1968 Corvette: Service Bulletin: Heat Damage to Engine Wiring Harness at Starter Solenoid

Source: Chevrolet Dealer Service Technical Bulletin

Bulletin No: 68-T-66

Date: October 30, 1968

Figure 1

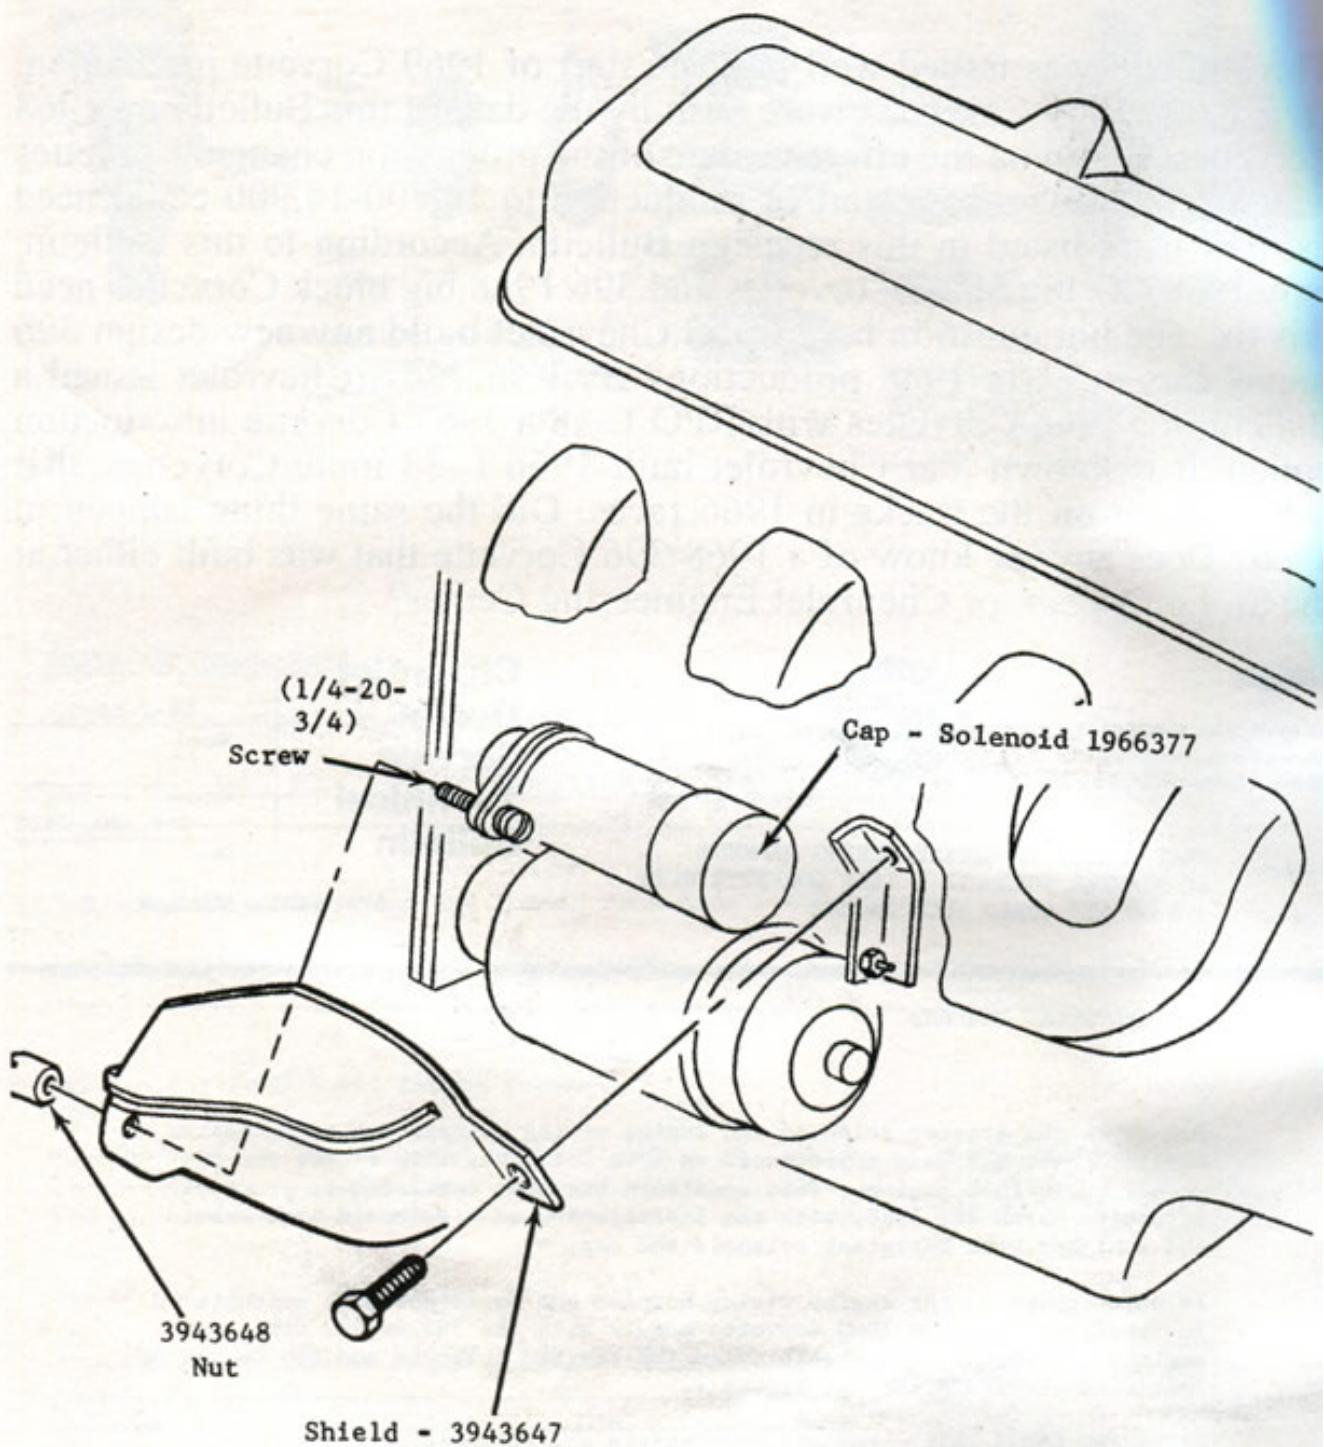
Damage to the starter solenoid and engine wiring harness due to excessive manifold heat has been experienced on 1968 Corvettes with either the 396 or 427 cubic inch engine. This condition has been corrected in production effective March 28, 1968, with the installation of a solenoid heat shield and a higher heat resistant solenoid end cap.

If heat damage to the engine wiring harness and/or solenoid is encountered in the field on early 1968 Corvette models with the 396 or 427 cubic inch engine, the solenoid heat shield and the revised solenoid end cap should be installed as illustrated in figure 1.

Installation of Heat Shield
and Solenoid Cap
